Ref: FCC Class II Permissive change for FCC ID: 2ADH6-190209RC

This is to request a Class II Permissive change for FCC ID: 2ADH6-190209RC originally granted on July 28, 2023.

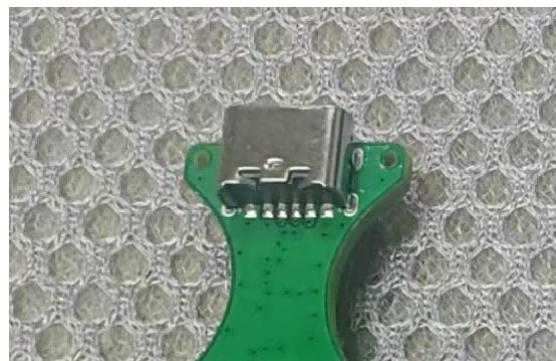
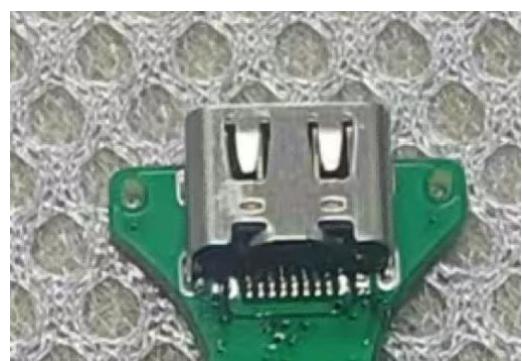
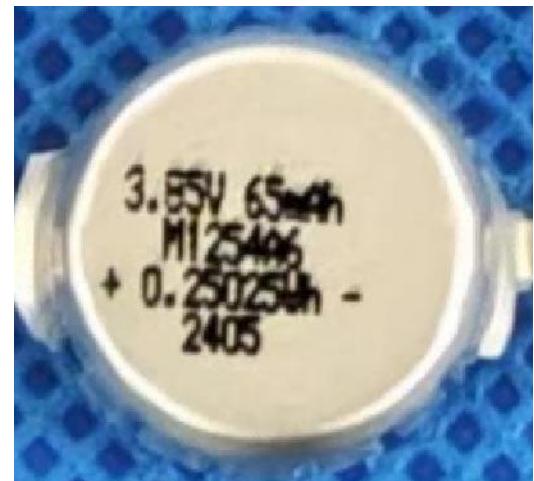
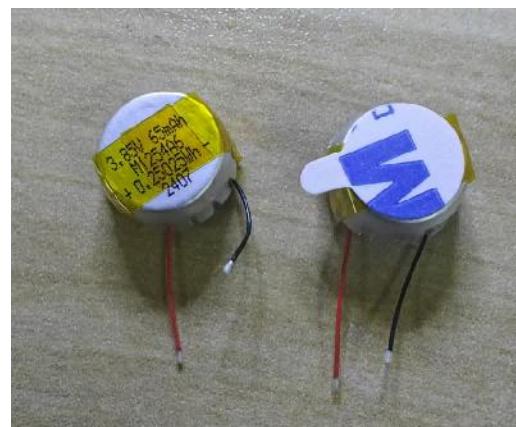
The headphone battery is changed from DC 3.7V to DC 3.85V 65mAh, and the charging bin circuit is changed: the Type-C seat is changed from 6PIN to 16PIN
